TECHNICAL NOTE TN-1179
T2000 - Obsolescence of the
TDA1020 Audio Amplifier
26th May 2006

This Technical Note applies to the complete T2000 product range.

Fig' 1

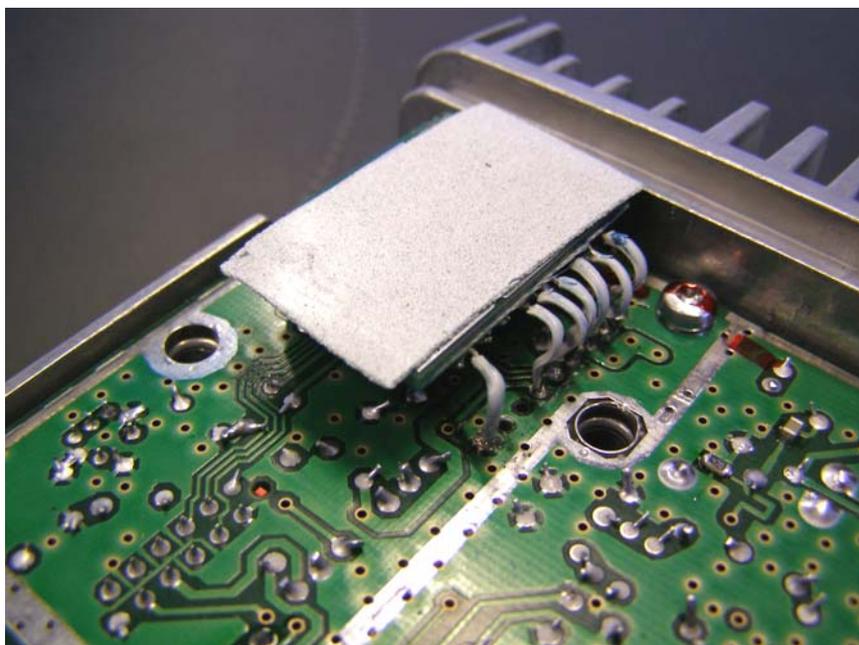
The TDA1519 audio amplifier daughter board (**T2000-ATDA**) is a direct “drop in” replacement for the TDA1020 (IC402). Simply remove the TDA1020, and solder in the wires attached to the daughter board. The only difference is that the daughter board is fitted between the RF PCB and the Bottom Cover (Refer Fig 1). A foam pad (IPN 369-02054-10) is placed between the daughter board and the PCB to prevent the vibration of the PCB and a Gap Pad (IPN 369-01049-00) is placed between the Bottom Cover and the daughter board. This Gap pad acts as an electrical insulator and helps with heat sinking. Both of the pads are supplied with the T2000-ATDA kit.

Fig' 2

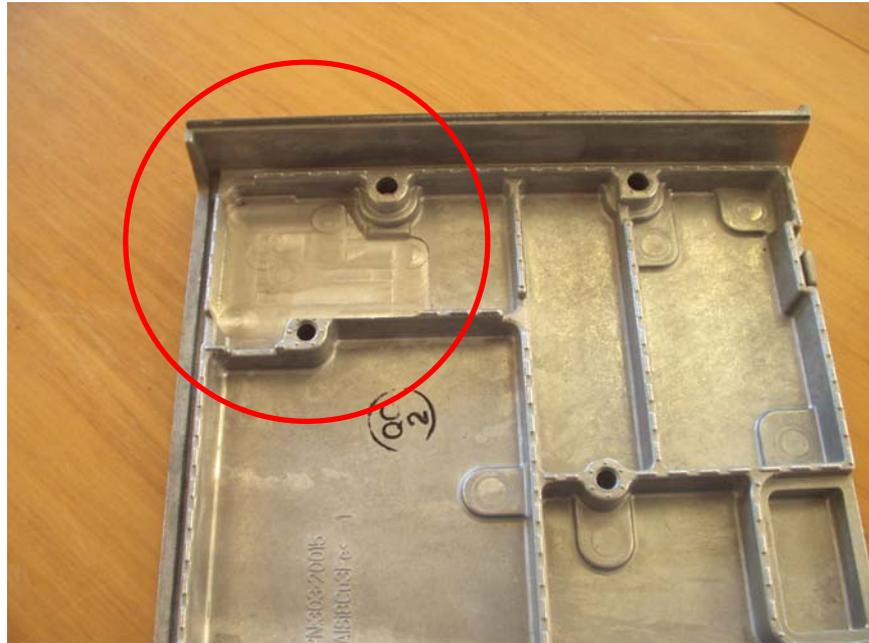
One other change that is necessary is that the bottom cover needs to be milled (see Fig' 2). This means that if a TDA1020 is being replaced by a TDA1519 then the bottom cover is very likely to need replacing (IPN of milled bottom cover = 303-23187-00). Once existing stock has been modified all T2000s will use the milled bottom cover.
